Attachment F

PG&E's Comments on the North Fork Feather River Listing for Water Temperature

Figure F-1. Water Segment Delineation for the North Fork Feather River for Water Temperature Assessment

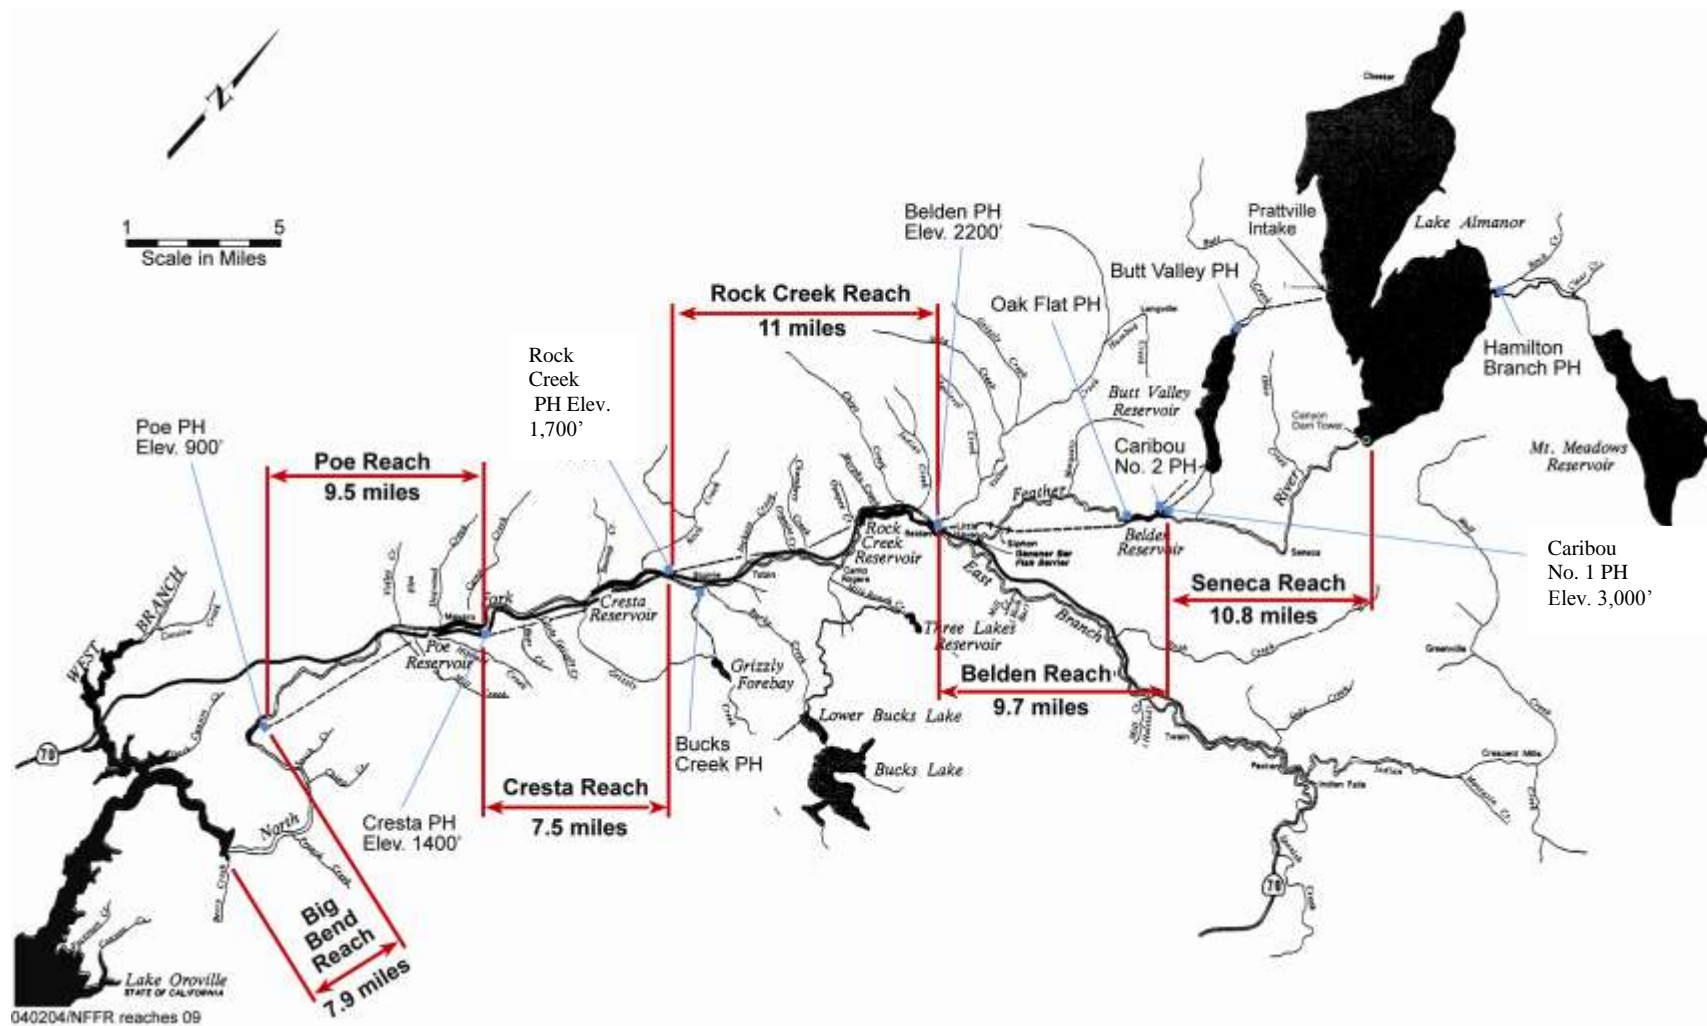
and the data correlated with each segment. Factsheets for each reach of the NFFR (Seneca, Belden, Rock Creek, Cresta, Poe, and Big Bend) are provided in this submission and include information regarding the health of each river segment based upon the most recent readily available data from the specific water segments (see Figure F-1).

Figure F-2. Historical and Current Trout Composition Percentage for Belden Reach .

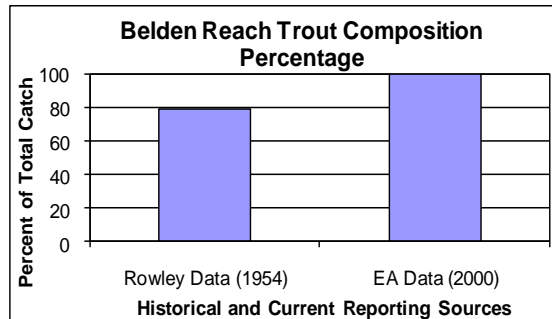
Angler surveys conducted in this reach in 2000 by EA Engineering, Science, and Technology (2001) reported a catch rate of 0.66 trout per hour, in which 100% of all fish caught were rainbow trout, and that 20% of the trout caught were equal to or greater than 11 inches long (Figure F-2. In general, these were all greater than the data reported by Rowely (1955), and are shown in Table F-1 and in Figure F-2 below.

Adult catchable trout per mile of stream reach relative to other California streams based on Table 2 in Gerstung (1973) is presented in Table 34, ECORP (2003), and show that the average sampling site in the Belden Reach was in either the top 17% or 46% for each sampling effort (2000 – 2002). Based on the relatively high composition percentage of rainbow trout and catchable sized trout relative to Gerstung (1973), this stream reach should be considered biologically healthy regardless of periodic exceedances of annual maximum temperature guideline presented in Sullivan et. al. (2000).

fish populations in Belden Reach. Therefore, this water segment should be removed from the 303(d) list of impaired water bodies.

Figure F-3. Number of rainbow trout caught per hour by study year for Rock Creek Reach

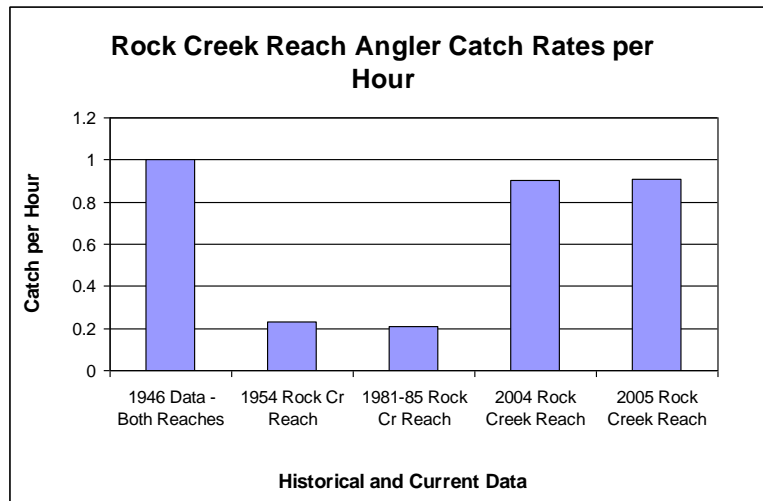
Angler surveys conducted in this reach in 2005 reported that 74% of all fish caught were rainbow trout, with an average length of 12.3 inches and with almost 7% of them being equal to or greater than 17 inches long. Angler catch per hour in 2004, and 2005 for the riverine portion of the Rock Creek reach was 0.90 and 0.91 trout/hour, respectively, which is very close to the 1 fish/hour reported for the pre-project period (1946) by Wixom (1989). Table F-2 and Figure F-3, below, compare all of the trout/hour data presented in the original listing along with the most recent data from 2004 and 2005. Based on the relatively high composition percentage of rainbow trout reported in the angler surveys and success rate (catch /hour), this stream reach should be considered biologically healthy regardless of the periodic water temperature exceedances of the Sullivan guideline.

The available current data show that water temperature alone is not a good measure of the health of water segments as displayed by the healthy fish populations and catch per hour of rainbow trout in 2004 and 2005 being nearly equal to the highest historical value listed for 1946 for the Rock Creek Reach. While there are some exceedances of the Sullivan guideline in this reach there are very few if any exceedances of the US EPA guideline. In addition, the elevation and climatic influences on the waters in this reach are greater compared to the waters originating at Canyon Dam approximately 20.5 miles upstream and at an elevation approximately 2,800 ft greater than at this end of this reach (at the Rock Creek Powerhouse). Therefore, this water segment should be removed from the 303(d) list of impaired water bodies.

Figure F-4. Number of rainbow trout caught per hour by study year for Cresta Reach.

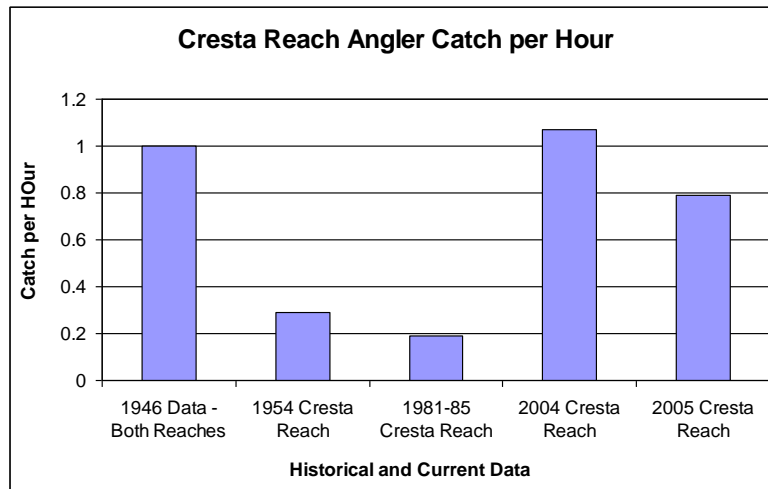
Angler surveys conducted in these reaches in 2005 reported that 74% of all fish caught were rainbow trout, with an average length of 12.3 inches and with almost 7% of them being equal to or greater than 17 inches long. Angler catch per hour in 2004 and 2005 for the riverine portion of the Cresta reach was 1.07 and 0.79 trout/hour, respectively, equal to the 1 fish/hour reported for the pre-project period (1946) by Wixom (1989) in 2004 and very close to it in 2005. Figure F-4 and Table F-3 below compares all of the trout/hour data presented in the original listing along with the most recent data from 2004 and 2005. Based on the relatively high percentage of rainbow trout reported in the angler surveys and success rate (catch /hour), this stream reach should be considered biologically healthy regardless of the periodic water temperature exceedances of the Sullivan guideline.

The available current data show that water temperature alone is not a good measure of the health of water segments as displayed by the healthy fish populations and catch per hour of rainbow trout in 2004 and 2005 exceeding or nearly equal to the highest historical value listed for 1946 for the Cresta Reach. While there are some exceedances of the Sullivan guideline in this reach there are very few if any exceedances of the US EPA guideline. In addition, the elevation and climatic influences on the waters in this reach are greater compared the waters originating at Canyon Dam approximately 31.5 miles upstream and at an elevation approximately 3,100 ft greater than at the end of this reach . Therefore, this water segment should be removed from the 303(d) list of impaired water bodies.
